RESPONSE TO REQUEST FOR ADDITIONAL INFORMATION

US-APWR Design Certification

Docket No. 52-021

RAI NO.: NO. 1025-7092 REVISION 3
SRP SECTION: 03.07.02 – Seismic System Analysis
APPLICATION SECTION: 3.7.2
DATE OF RAI ISSUE: 04/29/2013

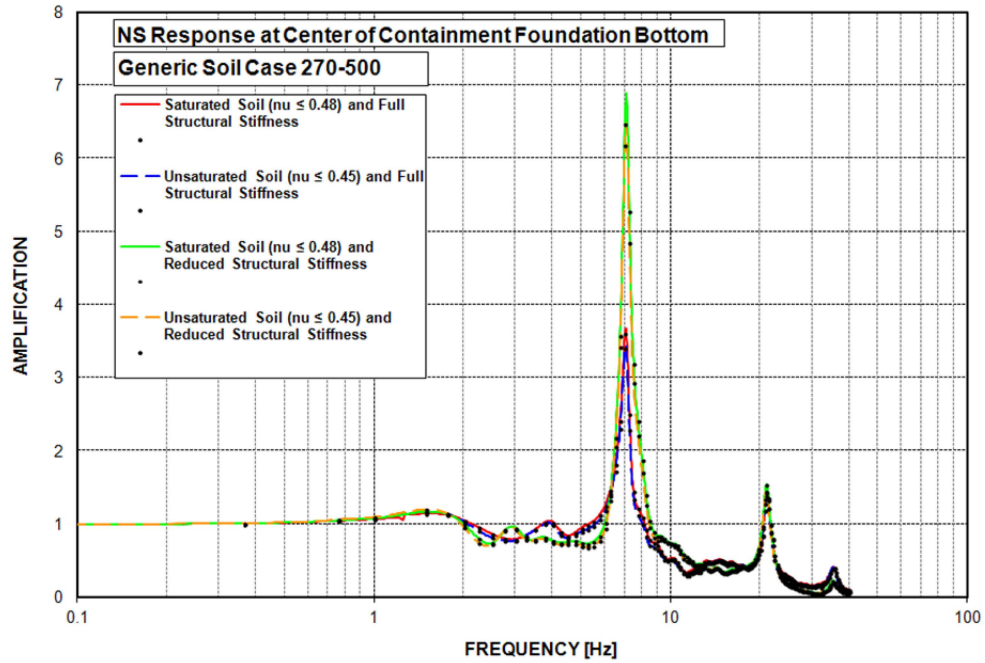
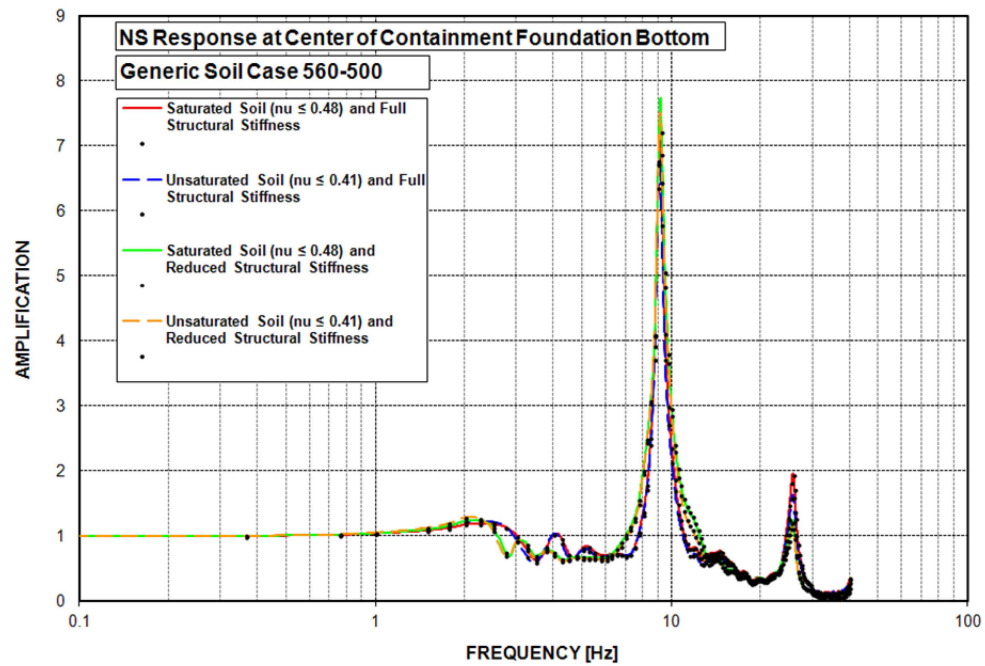
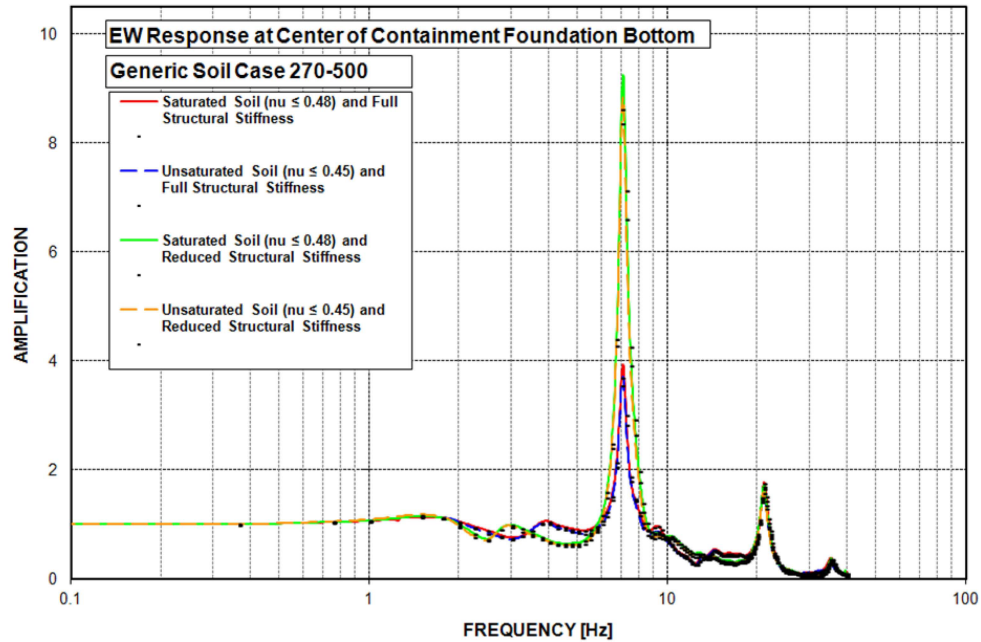
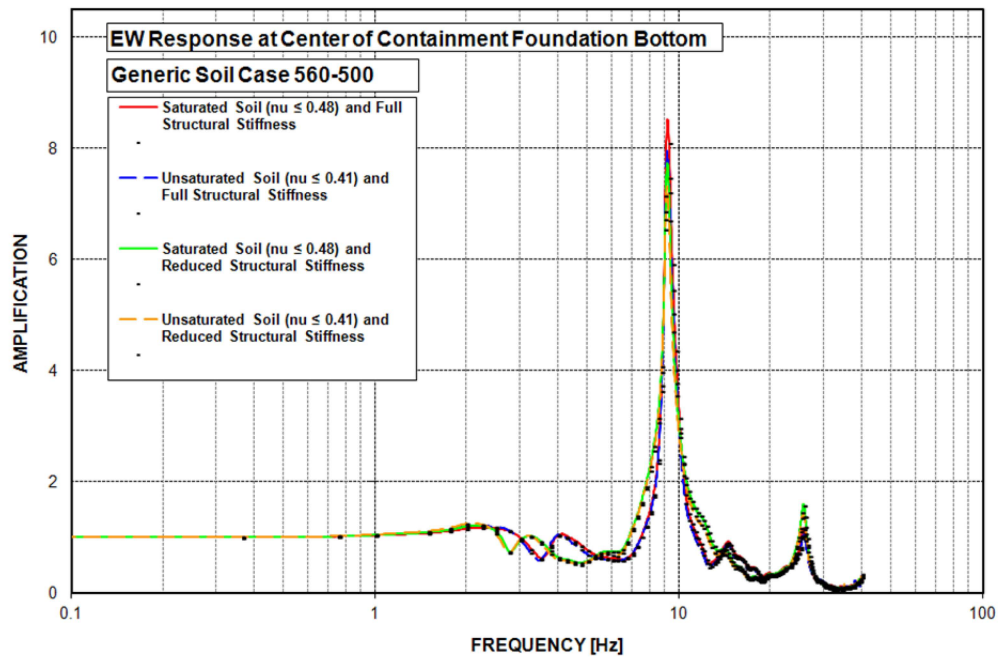
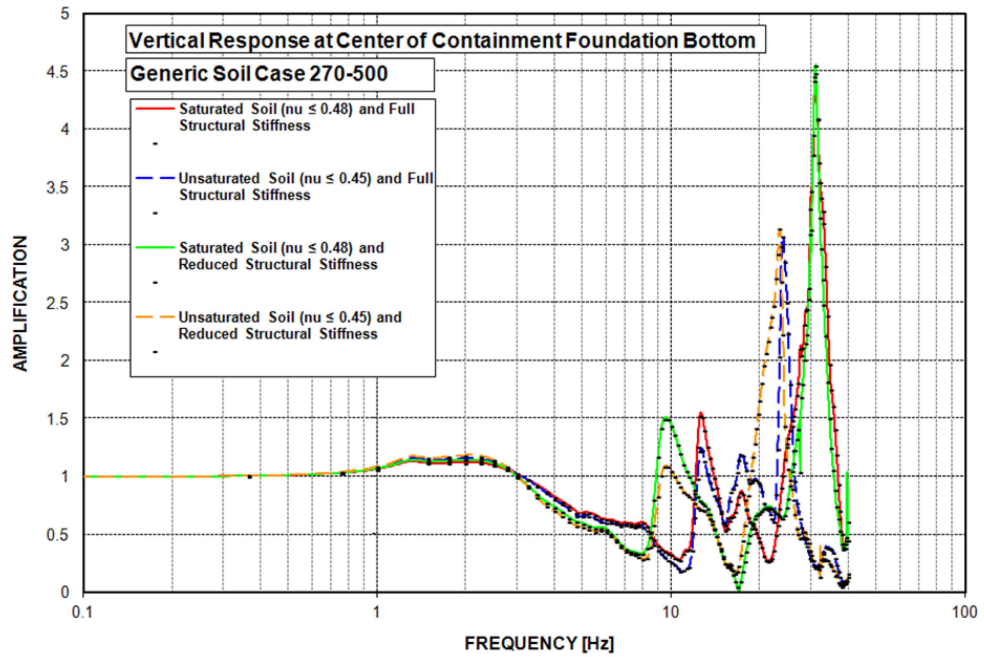
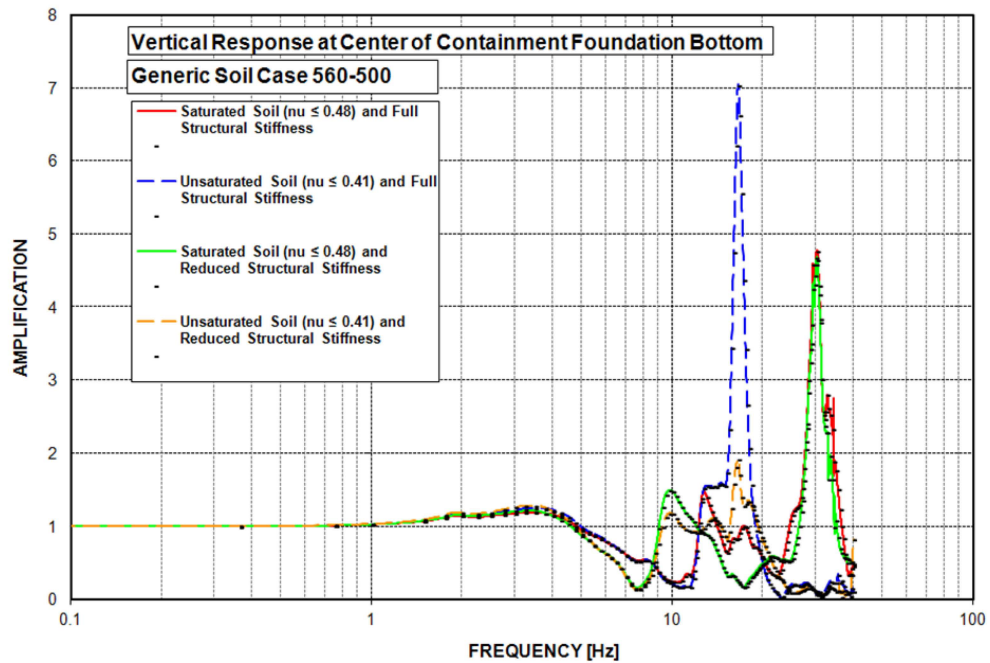
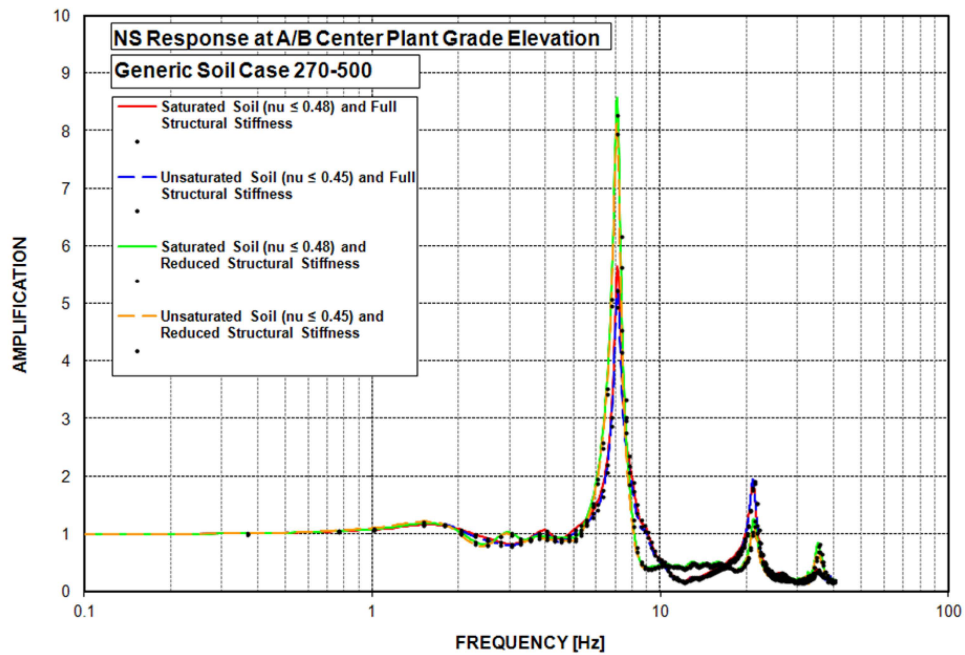
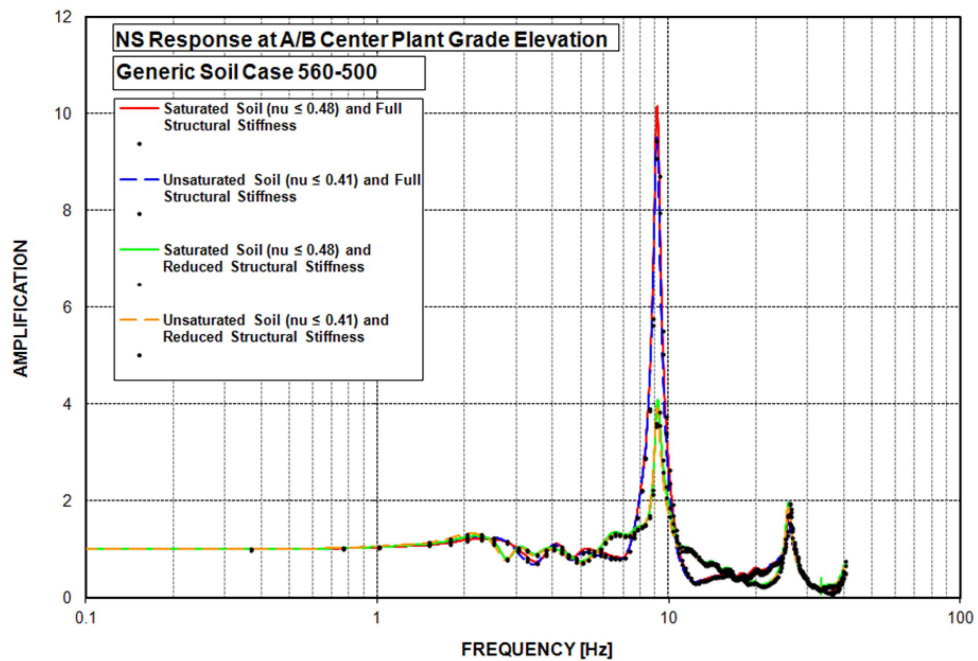
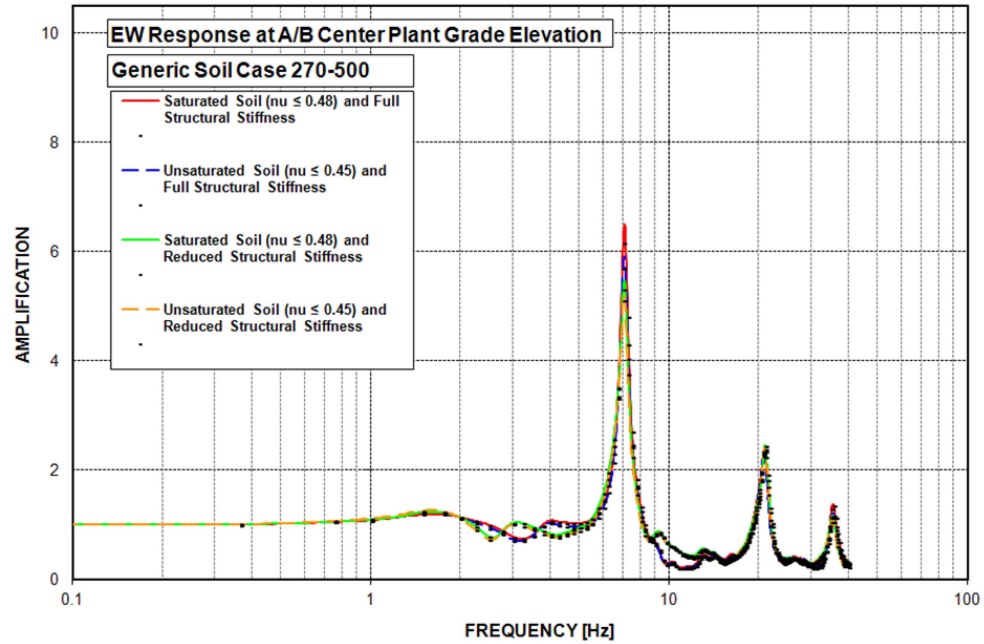
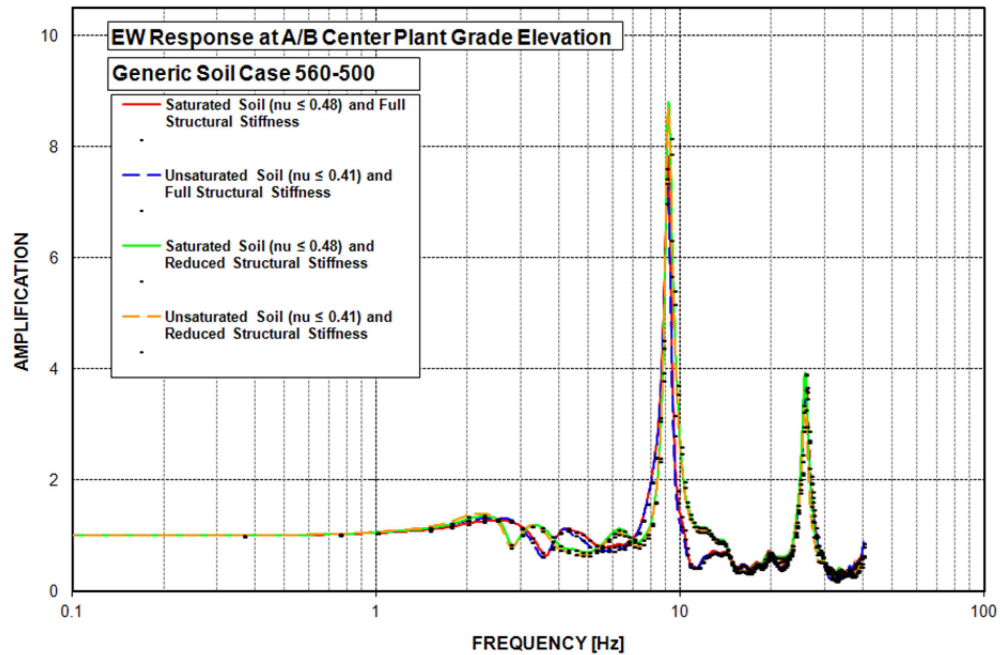
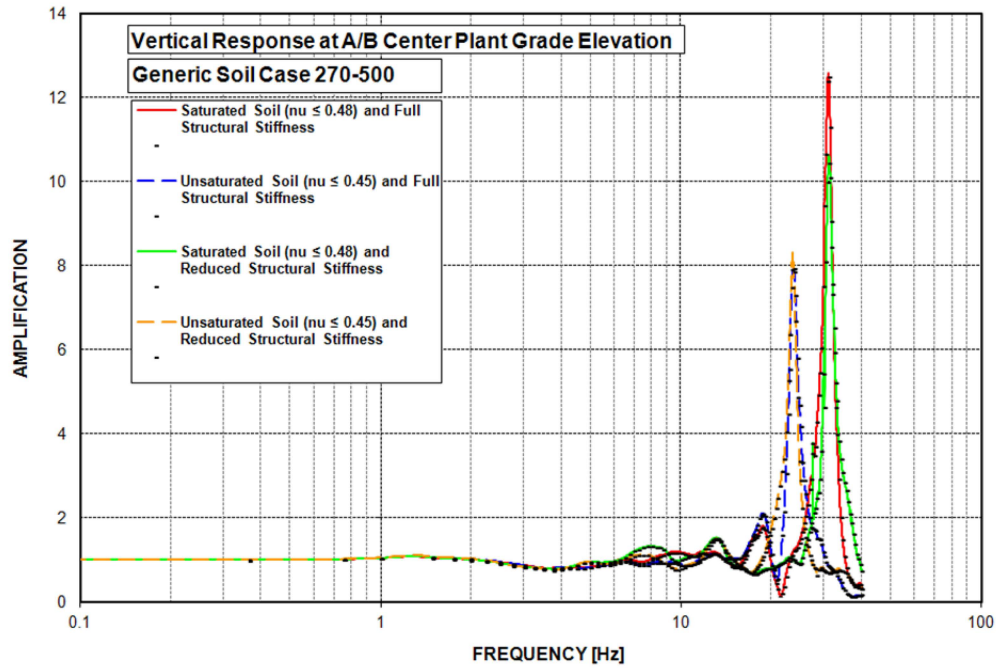
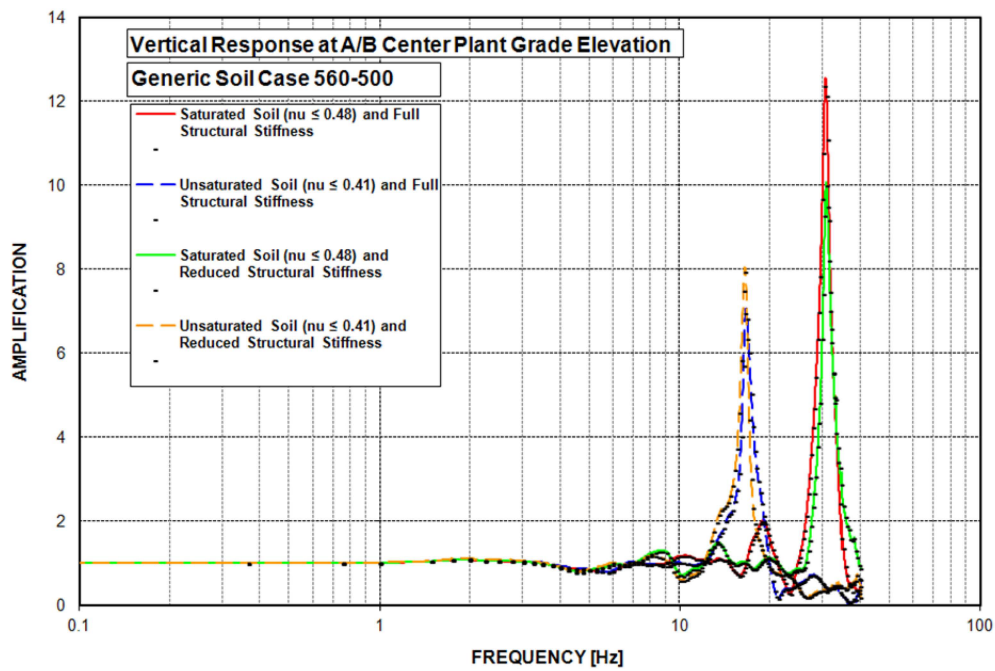
Section 2.3 of MUAP-11007 (R2) indicates that the Poisson's ratio used in developing the Pwave velocity of the saturated soil profiles approaches values close to 0.48, and that this value is low enough "not to compromise the numerical stability of the SASSI results."

The applicant is requested to provide (i) the basis for concluding that the numerical stability of the SASSI results is not compromised and (ii) the details of any specific sensitivity study that show that the ACS-SASSI results for APWR SSI analysis are numerically stable for the selected site-independent soil profiles and the assumed values of Poisson's ratio.

Figure 1 through Figure 12 below present comparisons of transfer functions results for the response of the Reactor Building (R/B) complex in the direction of the applied control motion for saturated generic profiles 270-500 and 560-500 and unsaturated generic profiles 270-

500Dry and 560-500Dry. Transfer function results obtained from the SSI analyses of structural models with full and reduced stiffness properties are presented for two nodes, located at basemat bottom and plant grade elevations, where possible numerical instabilities in the SSI results due to high value of the soil Poisson ratio would be most apparent. Figure 1 through Figure 6 show the amplitude of the transfer functions at the center of the containment foundation bottom. Figure 7 through Figure 12 present transfer function results for the response at the center of the Auxiliary Building (A/B) basement at plant grade elevation. The interpolated transfer function results obtained from the SSI analyses of saturated and unsaturated profiles with higher and lower values of the soil Poisson ratio are shown with solid and dashed lines, respectively. The plots show the calculated values of the transfer functions with dots.

The figures show that the transfer function results do not indicate numerical instabilities in the results of the SSI analyses. The transfer functions obtained from SSI analyses of saturated profiles with a soil Poisson ratio approaching a value of 0.48 are very close and consistent with those obtained from the SSI analyses of unsaturated profiles with lower values of the soil Poisson ratio that remain below 0.45. The interpolated transfer functions are smooth curves without abrupt changes or spurious peaks, which would be indicators of possible numerical instabilities in the SASSI results.
